Proposed Turkey Point Units 6 and 7

Docket Nos. 52-040 and 52-041

FPL Revised Response to NRC RAI No. 02.05.02-2 (eRAI 5896)

NRC RAI Number: 02.05.02-2 (eRAI 5896)

Figure 2a. Map showing the earthquake location for the 12/14/2004 Caribbean Sea Region earthquake ($M_w 6.8$), the IRIS station locations used in the analysis (shown as black triangles in this and similar subsequent figures), and Turkey Point Units 6 & 7 site location.

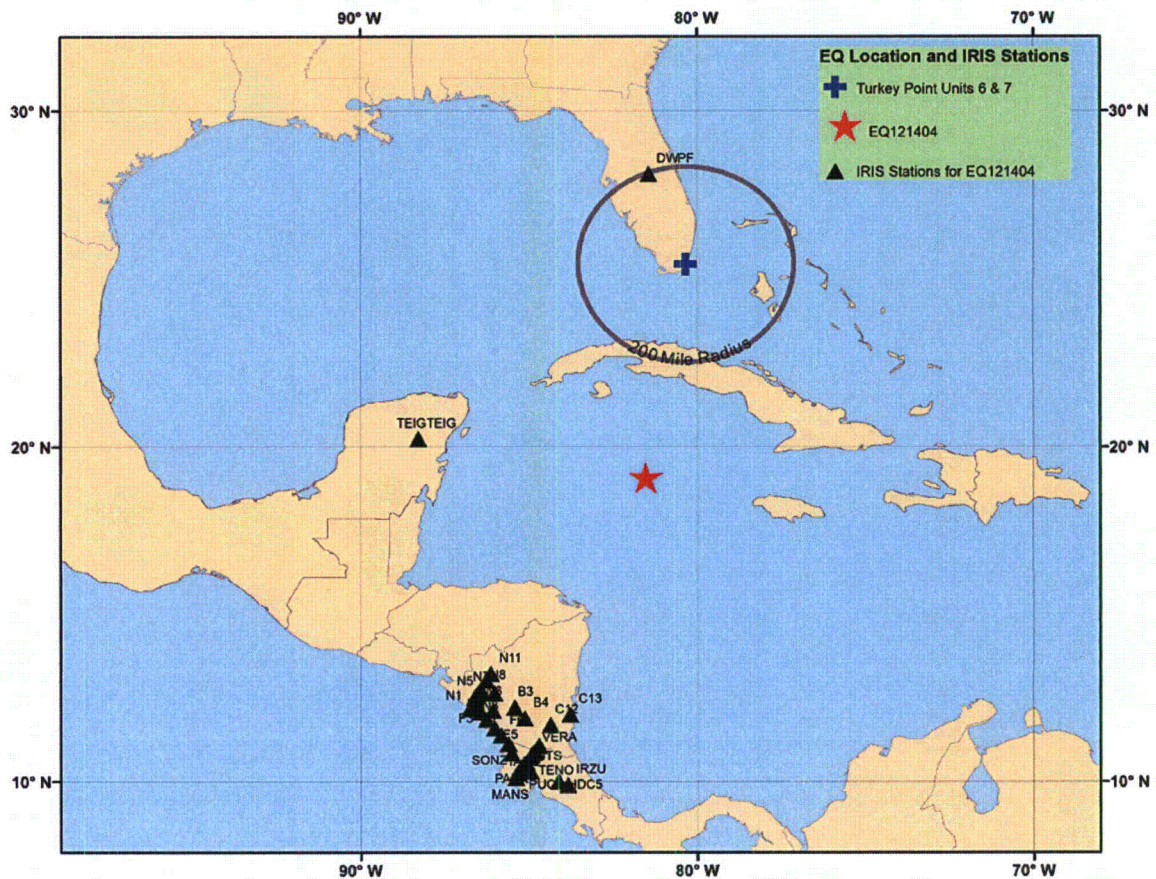
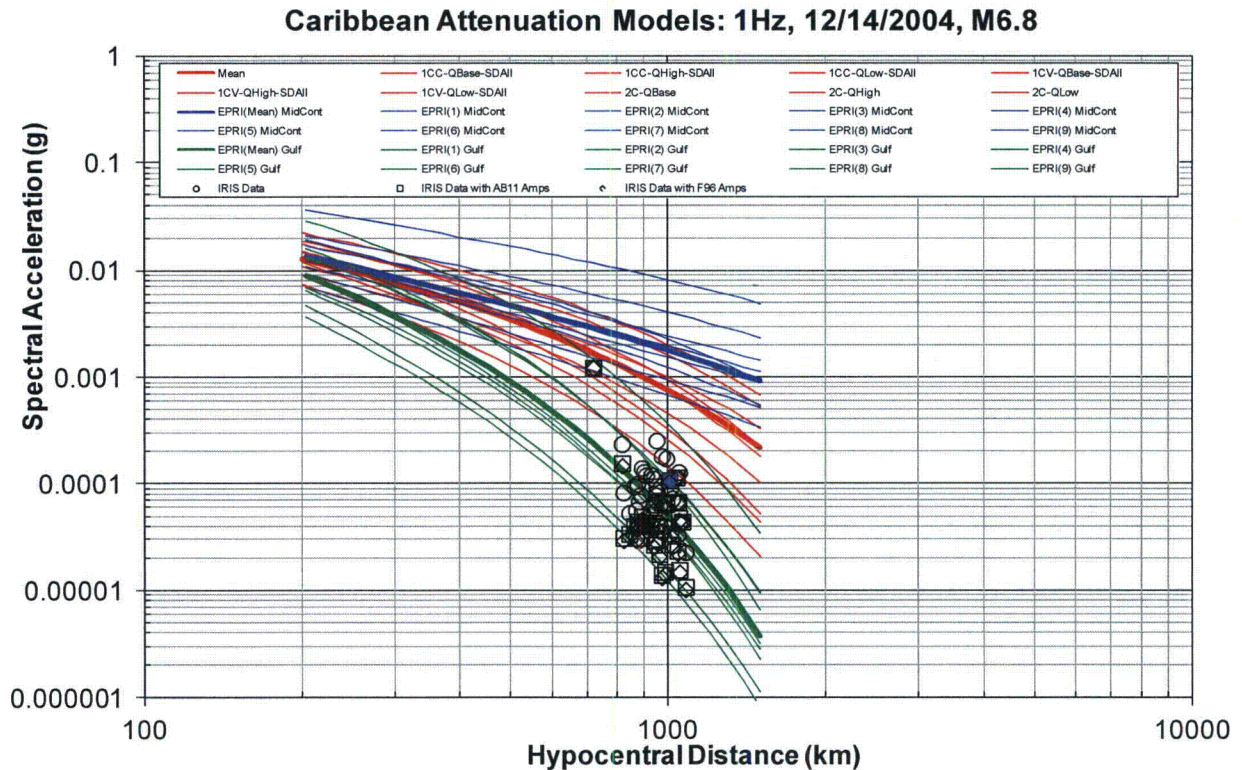
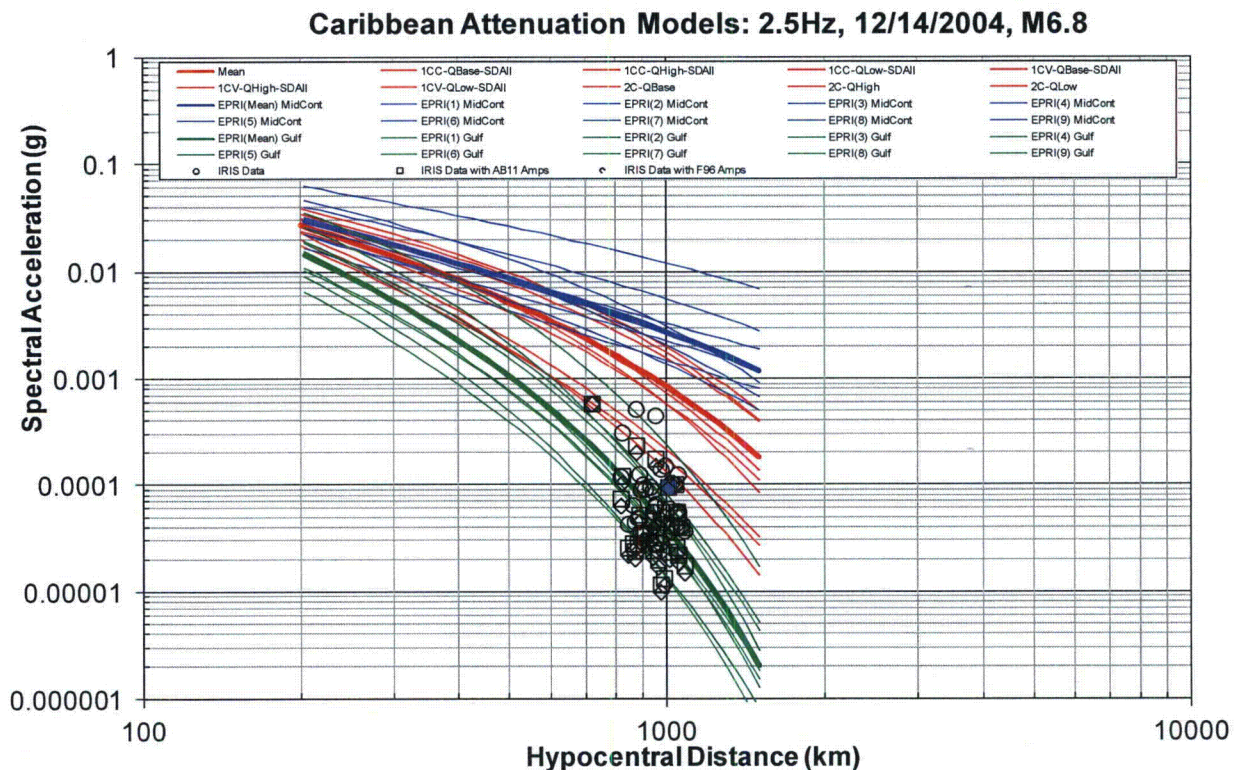
- a. Please explain why ground motion prediction models developed by Motazedian and Atkinson (2005) for the Puerto Rico region, which is primarily a subduction zone, provide an adequate basis for the larger Caribbean region, especially for the region between Cuba and Florida.

This event occurred in the Caribbean Sea region and its epicenter is shown in Figure 2a along with the Turkey Point Units 6 & 7 site location, and the location of the IRIS stations whose recorded data for this earthquake were analyzed. Based on the observed station distribution, the IRIS station DWPF located in central Florida has the most applicable

source to site path for this comparison. The GMPE curves and empirical data are shown in Figures 2b and 2c for the 1 and 2.5 Hz spectral frequencies. The data point from the DWPF station is highlighted as a solid blue symbol. The circle symbols are for the raw recorded IRIS data with no adjustment based on the difference in site conditions from the CEUS hard rock site conditions. The square and diamond symbols are the IRIS data adjusted using the two different amplification factors for CEUS hard rock site conditions and the free surface factor of 2 for TEIG and DWPF IRIS instruments not located on the ground surface. Overall the empirical data falls below the median Caribbean GMPE curve (heavy red line) and has values that are in the lower distribution range of Caribbean curves. In addition, the observation from the DWPF station is lower than the entire range of the Caribbean GMPE curves.

Figure 8. Magnitude 8 mean GMPE curves for PGA for the Caribbean (red curves), Mid-Continent (blue curves), and Gulf Coast (green curves) region GMPE models.

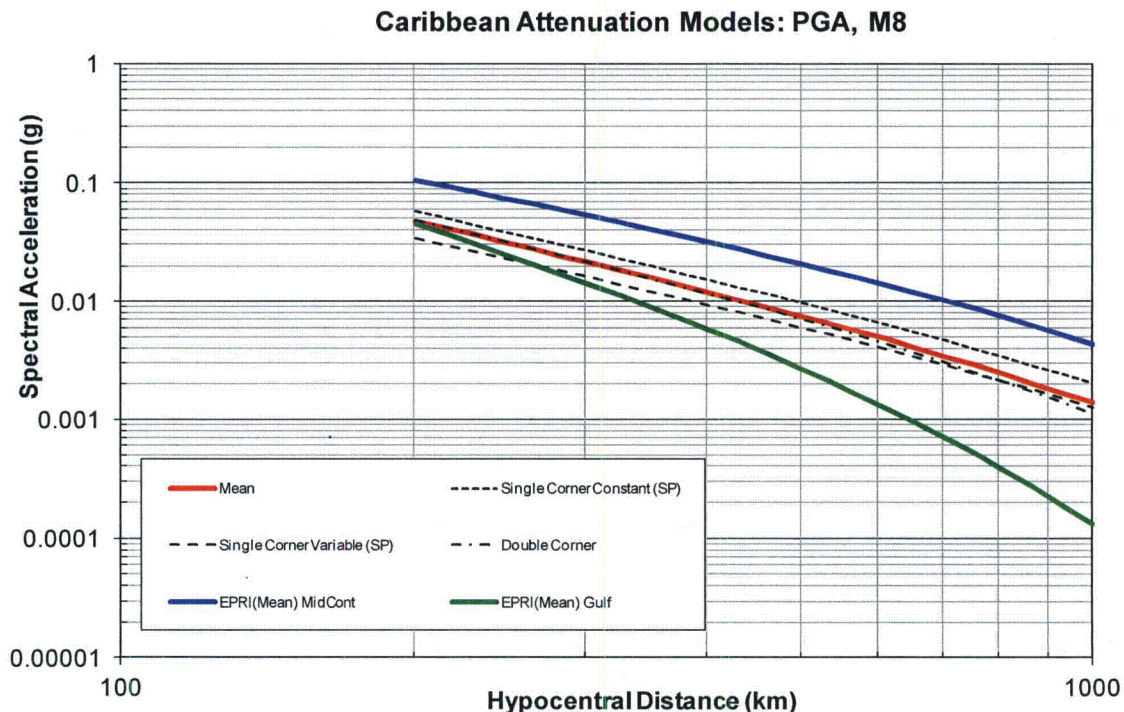
Dr. R. Youngs points out in his response to Question 7 of the expert elicitation, "The presentation of the comparisons on Figures 1-7 makes it very difficult to distinguish among the various relationships. It would perhaps be more useful to compare the median models of the EPRI (2004) (FSAR Reference 2.5.2-252) clusters with the three base case Caribbean relationships." Figures 1-7 in this context are Figures 1-7 of Enclosure 1 of this response, "SSHAC CARIBBEAN GMPE QUESTIONNAIRE."

Figure 8 below is the equivalent of Figure 1b of Enclosure A of this response modified as suggested.

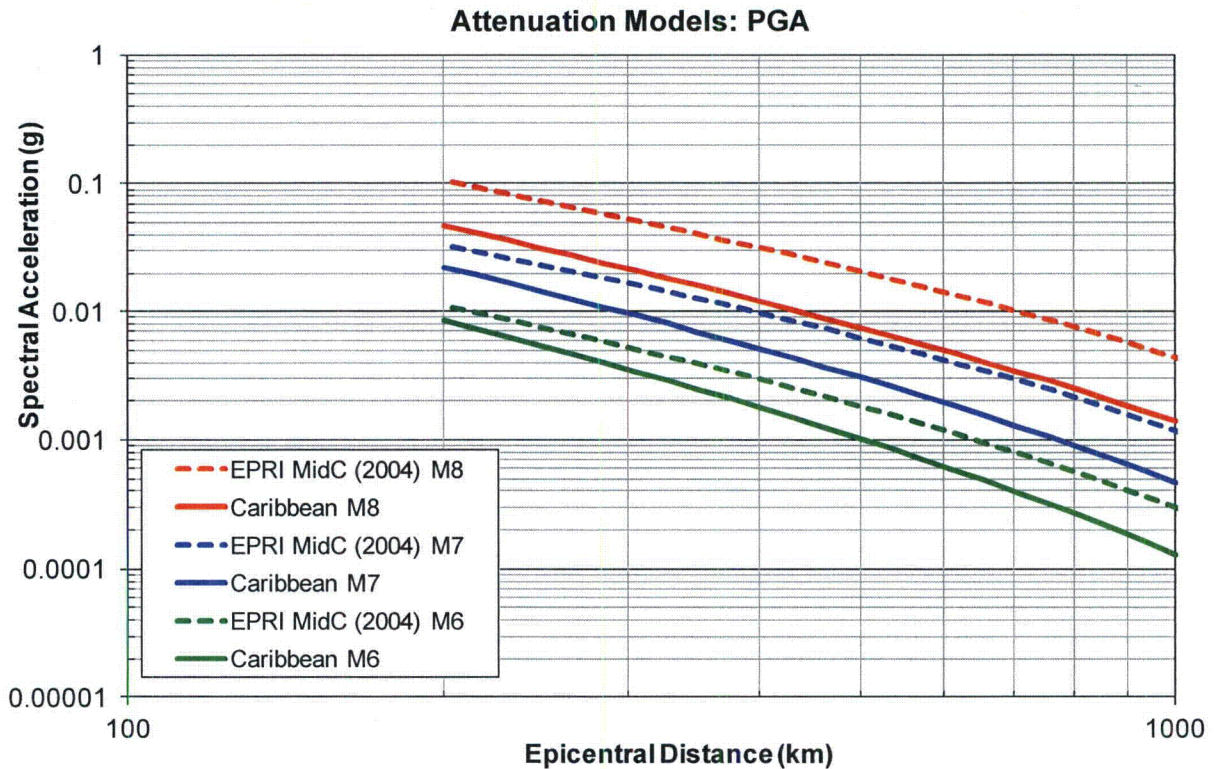
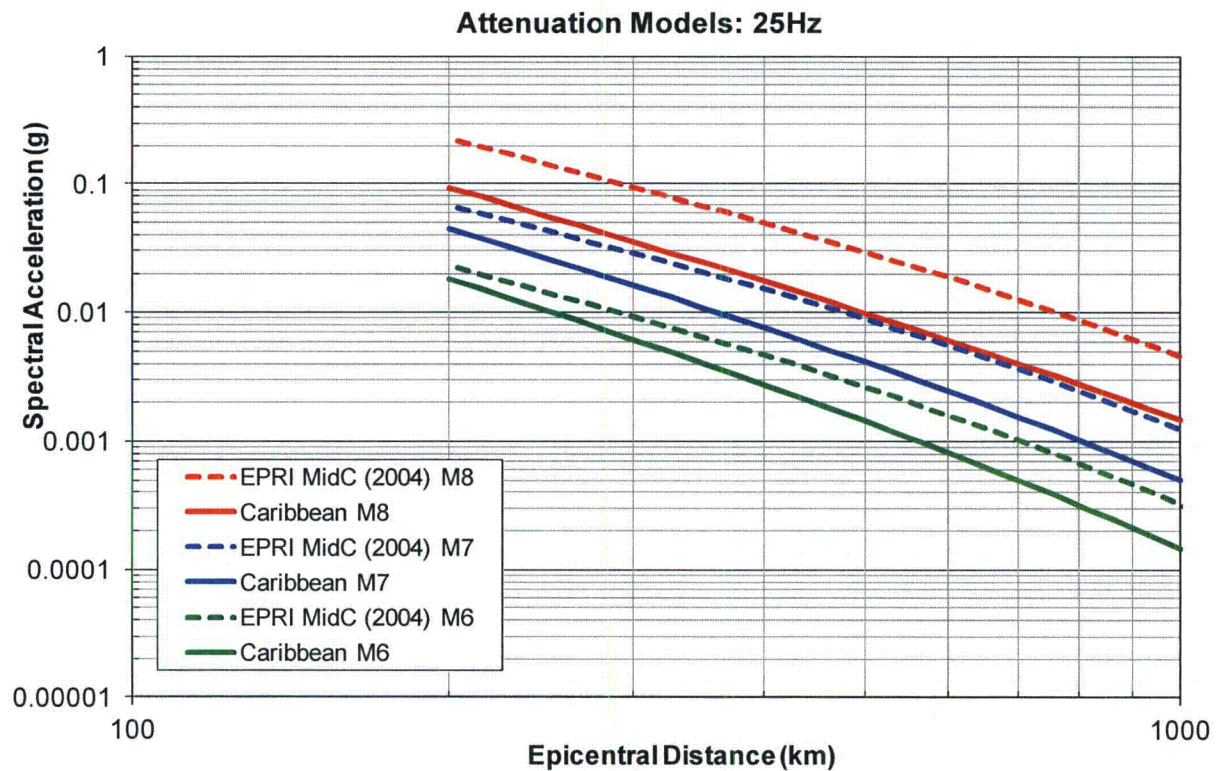
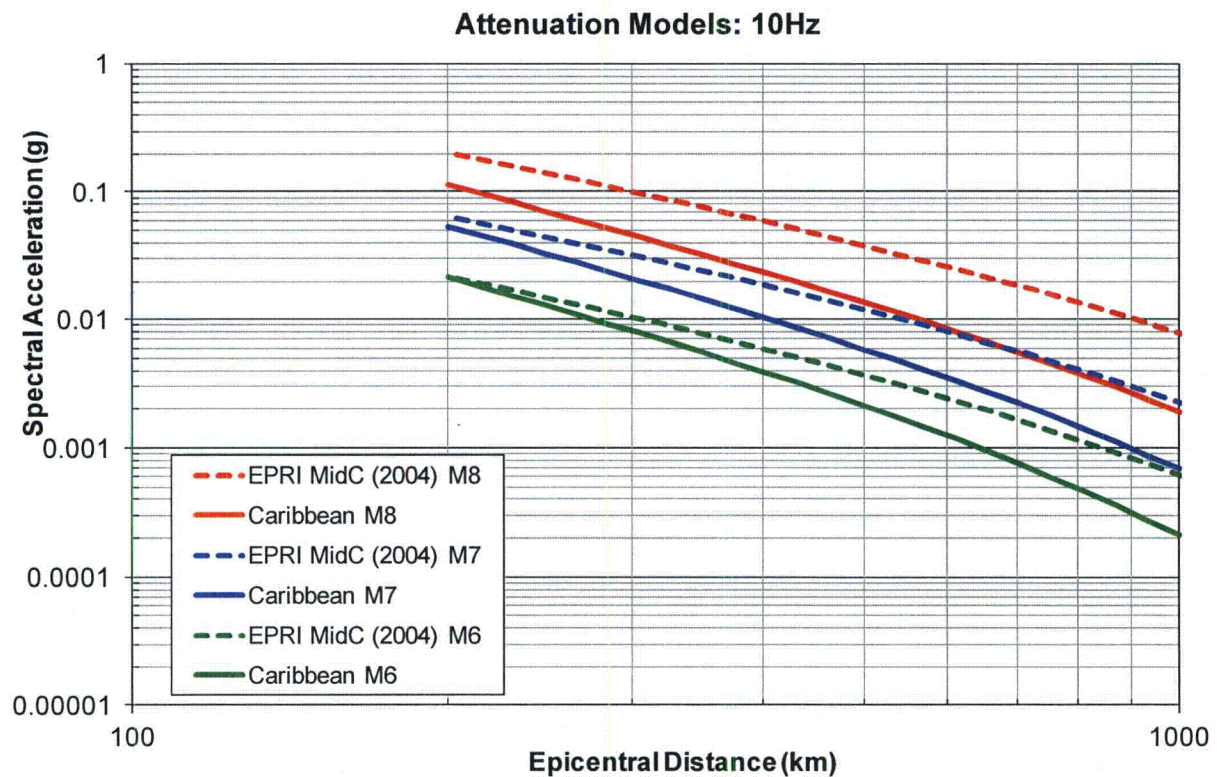
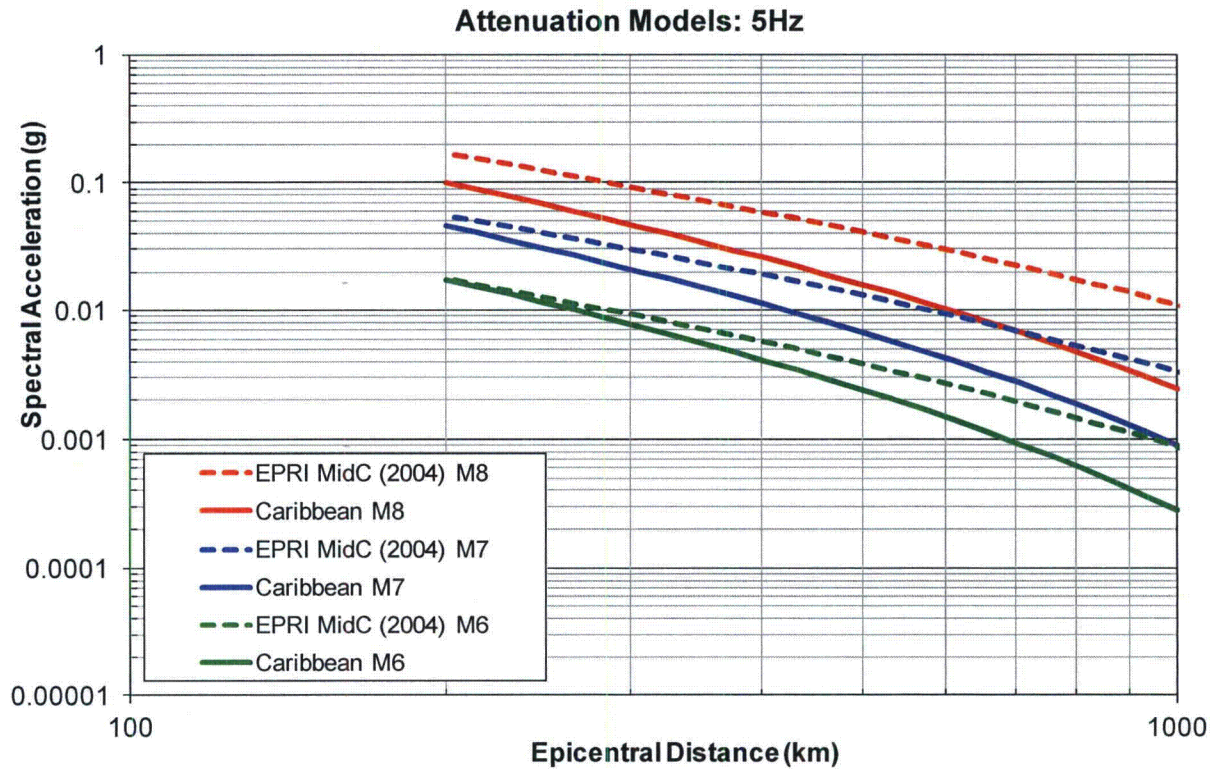
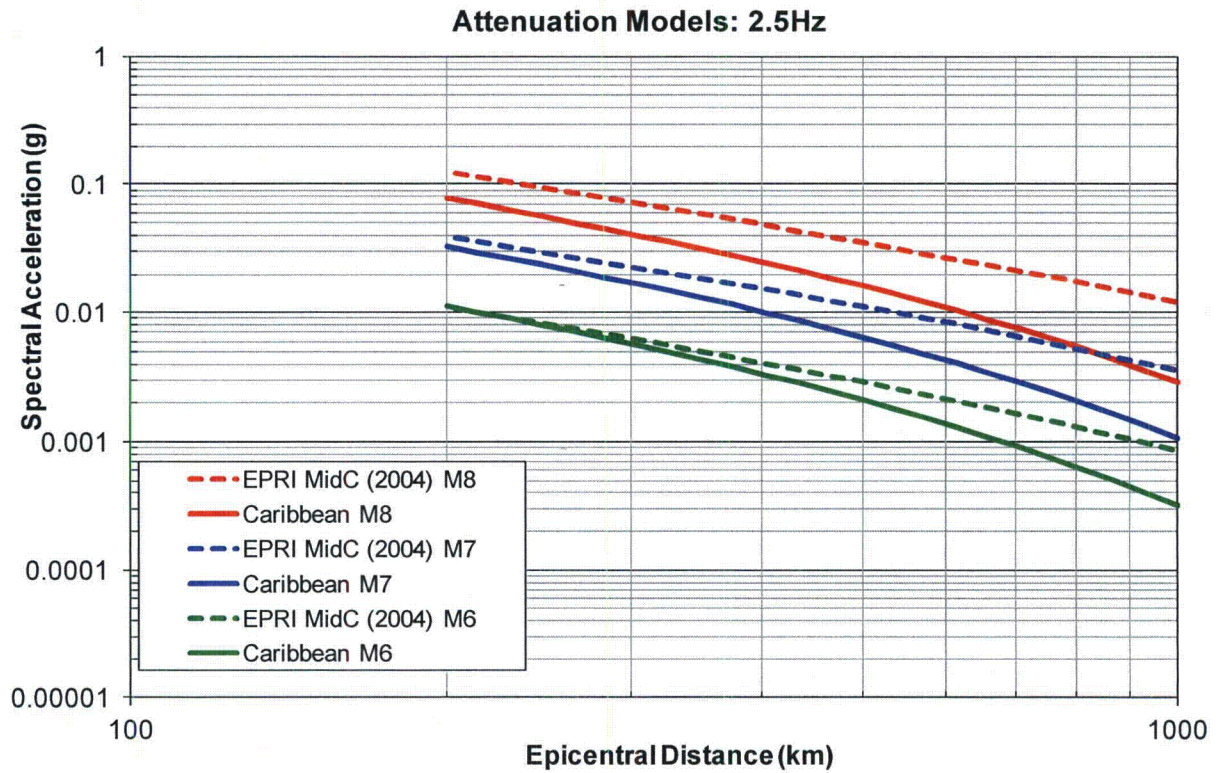
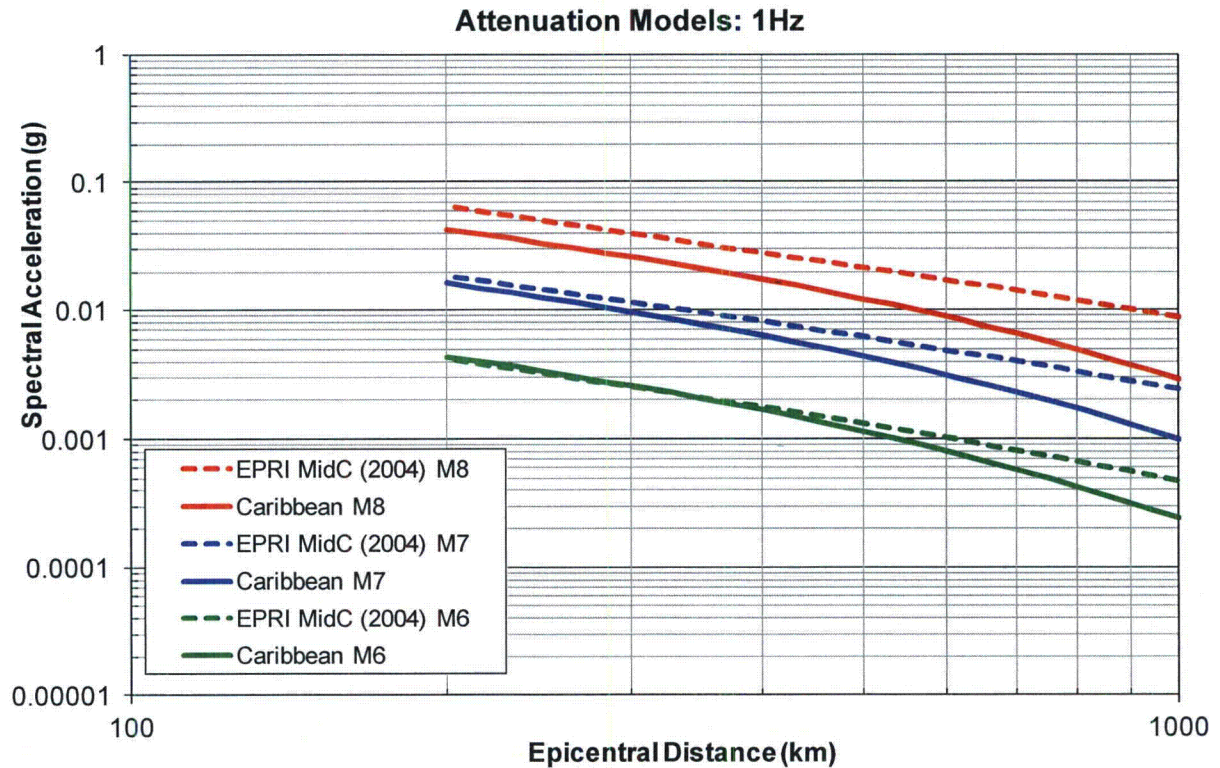
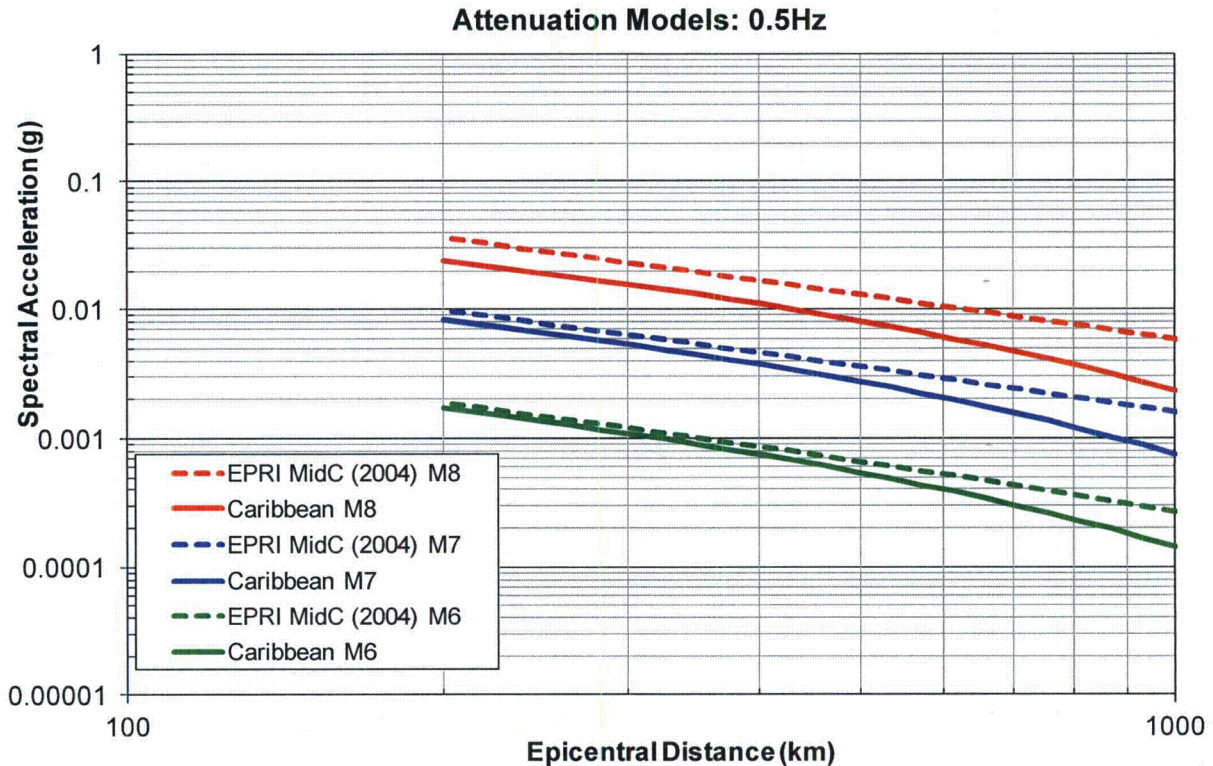
- d. In order for the staff to be able to compare the new Caribbean GMPEs with the 2004/2006 EPRI mid-continent GMPEs, please provide plots showing both ground motion models for earthquake magnitudes of 6.0, 7.0, and 8.0 in the distance range of 200 km to 1000 km at all seven frequencies defined in the EPRI 2004 and 2006 GMPEs.

Part d: In order for the staff to be able to compare the new Caribbean GMPEs with the 2004/2006 EPRI mid-continent GMPEs, please provide plots showing both ground motion models for earthquake magnitudes of 6.0, 7.0, and 8.0 in the distance range of 200 km to 1000 km at all seven frequencies defined in the EPRI 2004 and 2006 GMPEs.

only a recommendation for the associated aleatory uncertainty and therefore does not impact the comparison plots of the weighted mean GMPE curve. The plotted mean GMPE curve is the weighted mean of the individual median GMPE curves as defined in EPRI (FSAR Reference 2.5.2-242) and for the Caribbean GMPE models. These GMPE plots are provided for three specific moment magnitude (M_w) values: 6, 7, and 8 for distances between 200km and 1,000km. Note that the EPRI (FSAR Reference 2.5.2-242) GMPE model is defined as a function of epicentral distance, whereas the Caribbean GMPE model is defined as a function of hypocentral distance. For these comparison plots, the GMPE curves are plotted as a function of epicentral distance and for the Caribbean GMPE curves an assumed hypocentral depth of 8 km was used.
